Block 16 Section 10

1.0 Context and Character

Landscape Civic spaces and courtyards

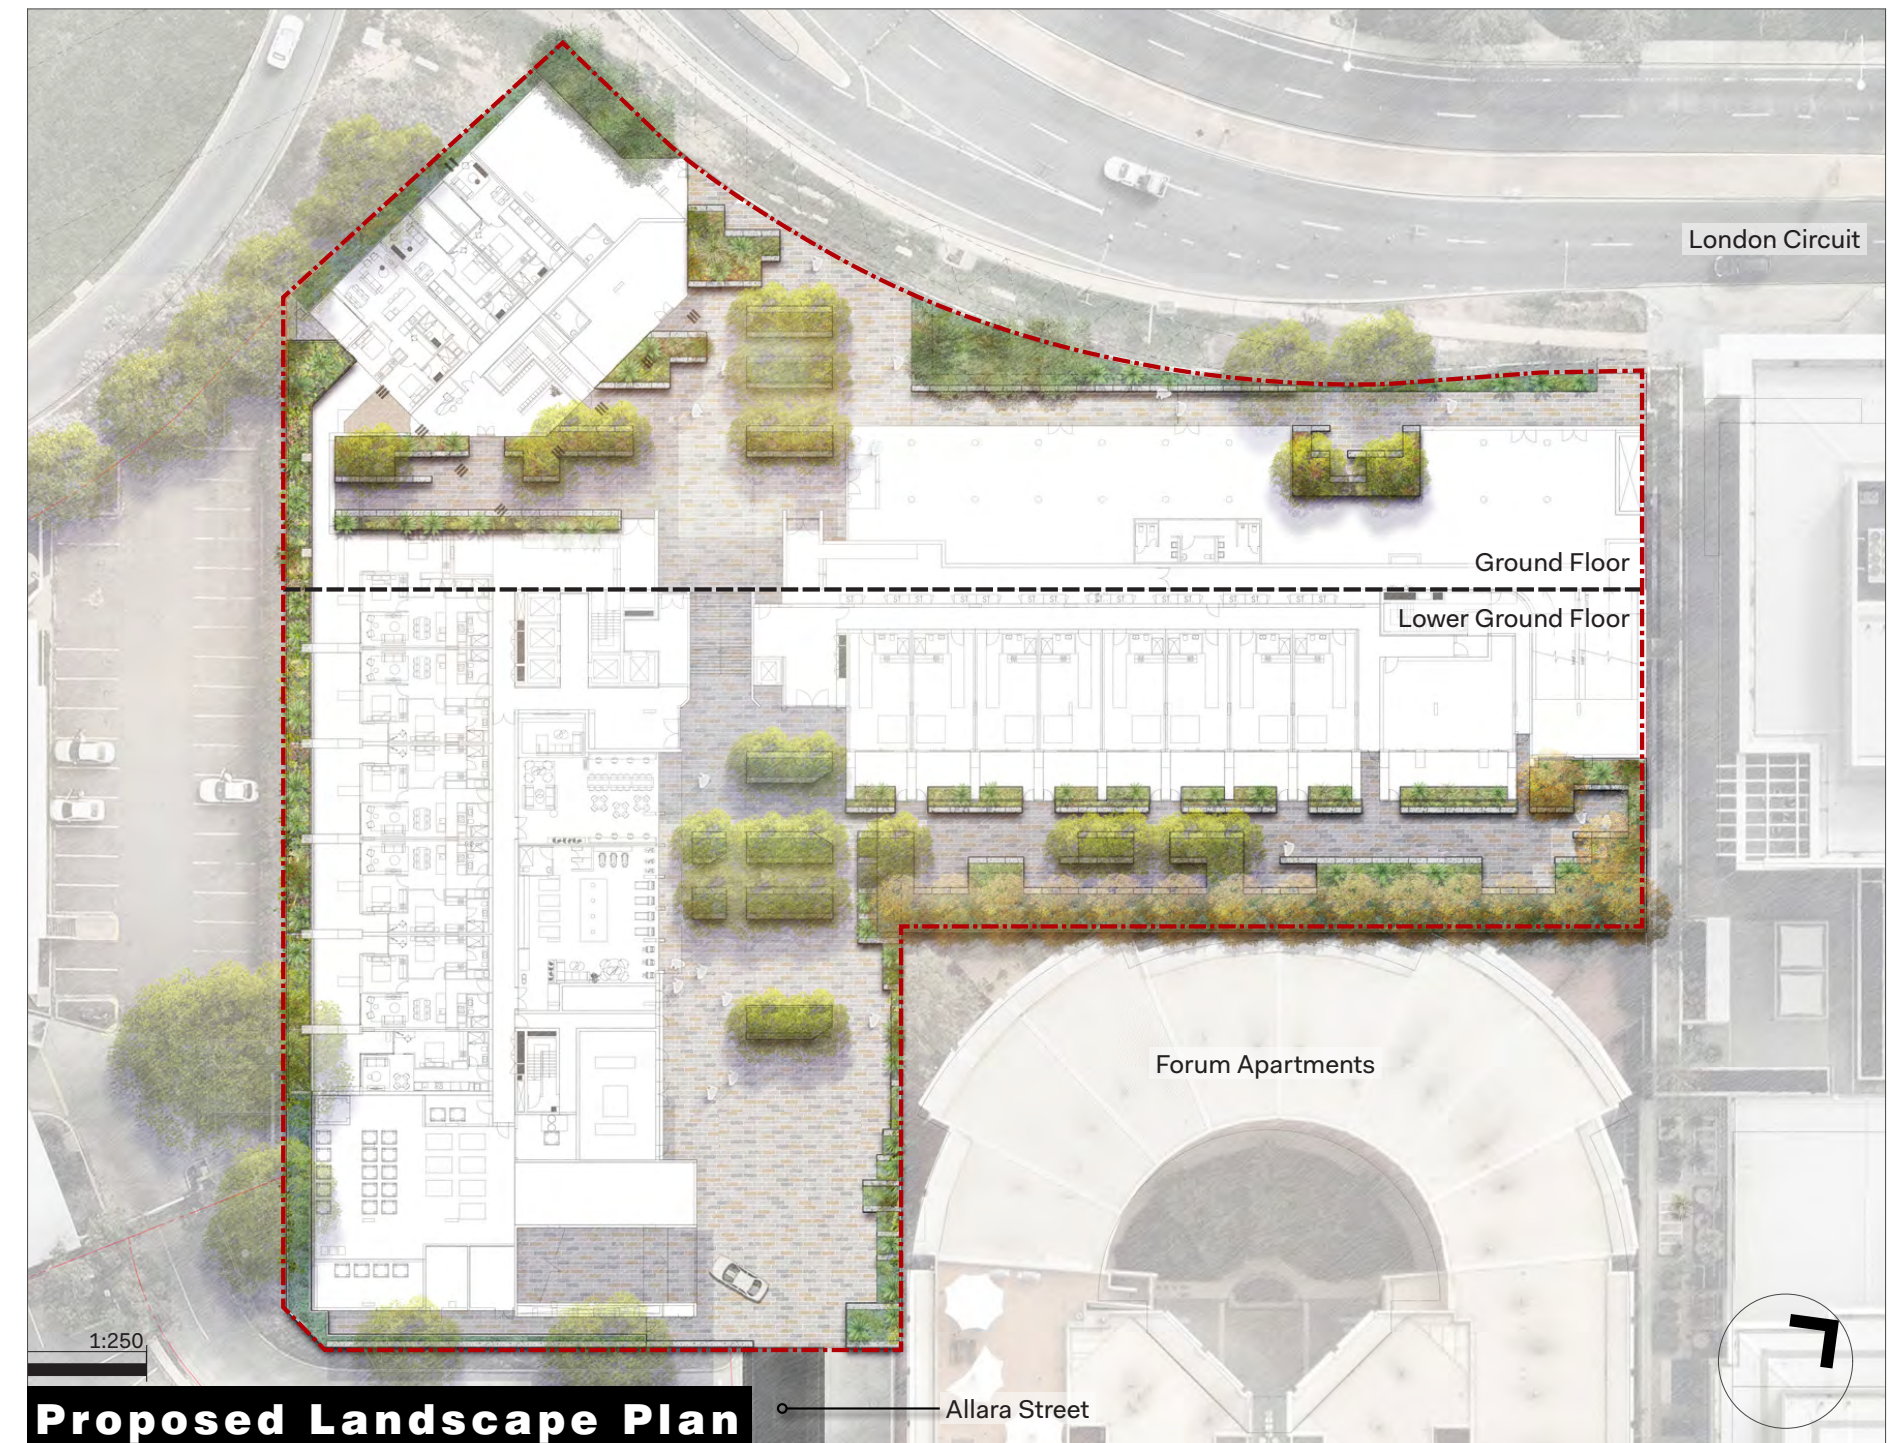
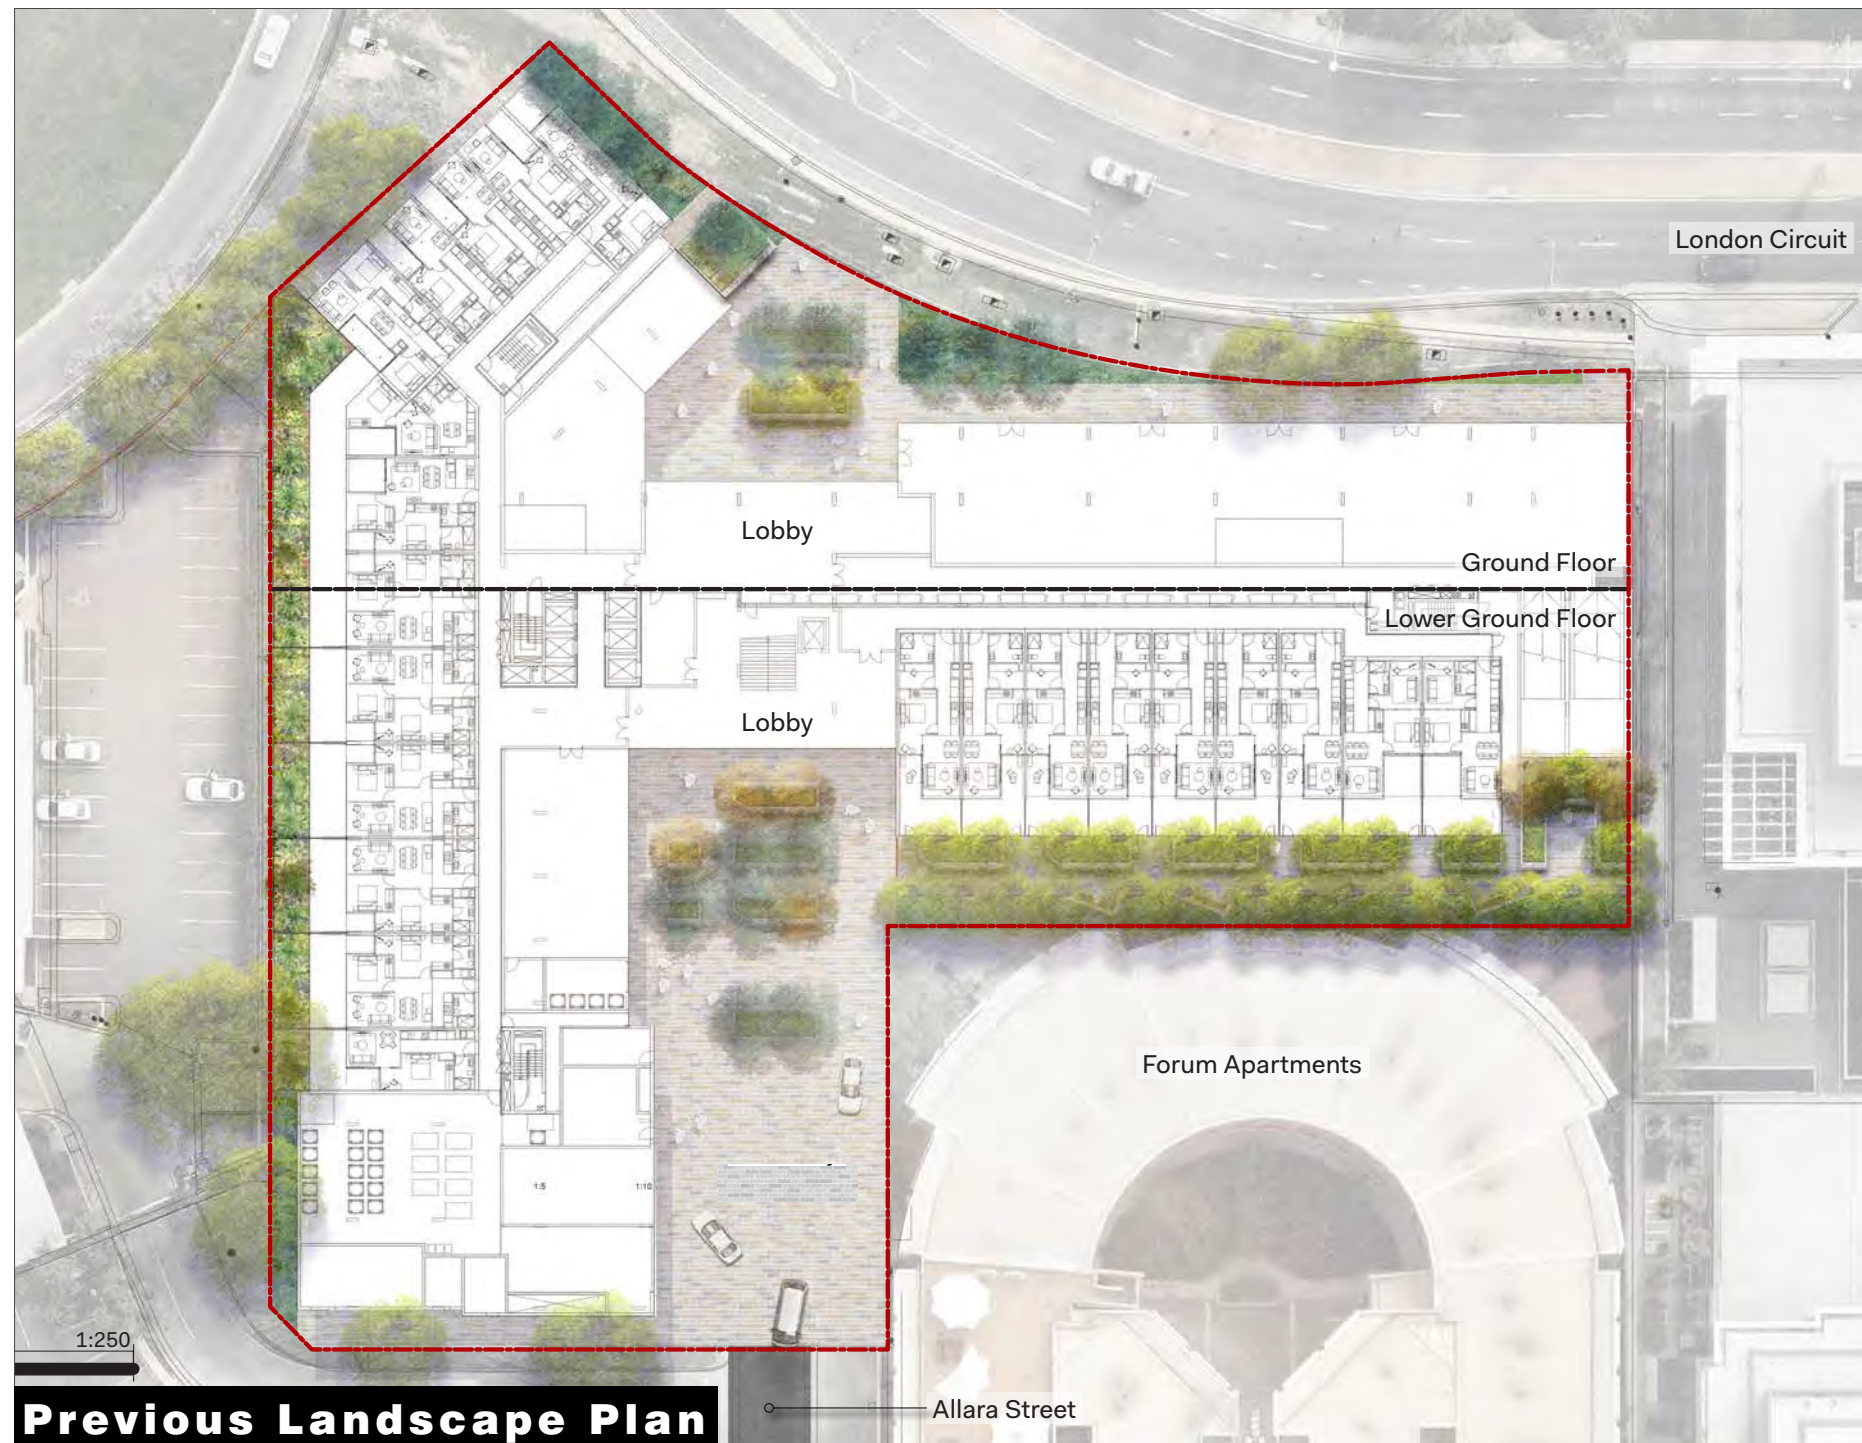
2.1 The landscape proposal as presented is considered by the Panel to illustrate an enticing outcome for the development however concerns regarding the character, bulk and scale of the civic spaces were expressed by the Panel. The proponent team is therefore encouraged by the Panel to consider how integrated external spaces could be better accommodated within the site. This may include division of building forms and alternate building articulation arrangements to facilitate generous courtyards spaces consistent with the inner courtyard typology characterised throughout this part of the city. The Panel therefore looks forward to seeing further development of the detailed landscape proposal at the next design review session.

Landscape Deep root soil

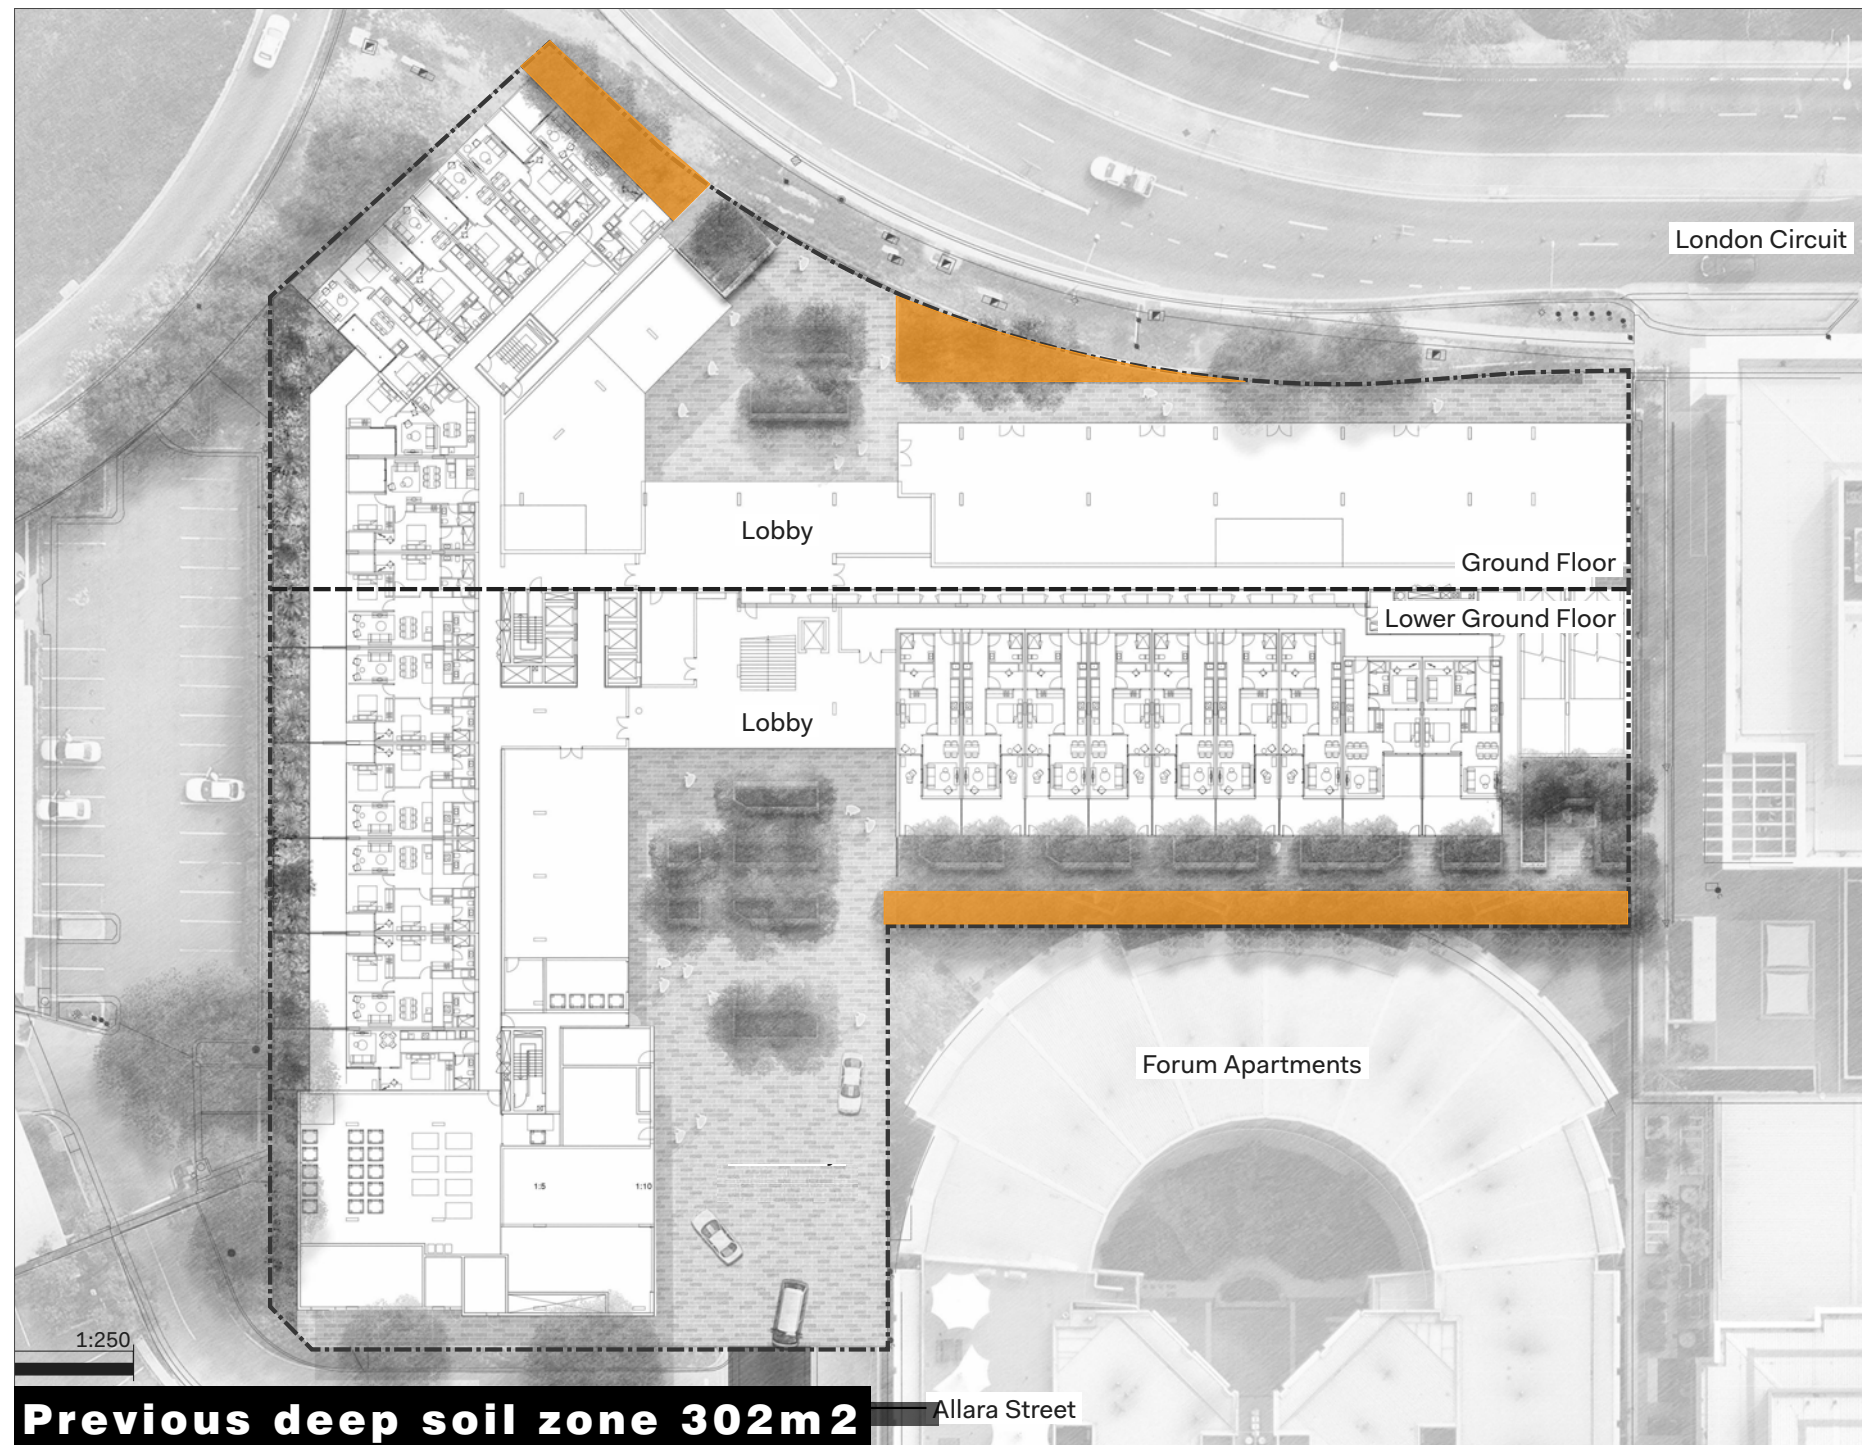
2.2 The inclusion of deep root soil zones for large canopy tree planting to London Circuit and the Forum Apartment interface is acknowledged by the Panel. As the proponent team continues to develop the proposal, the Panel recommends a greater emphasis be placed on providing deep soil zones in key spaces such as public and communal courtyards.
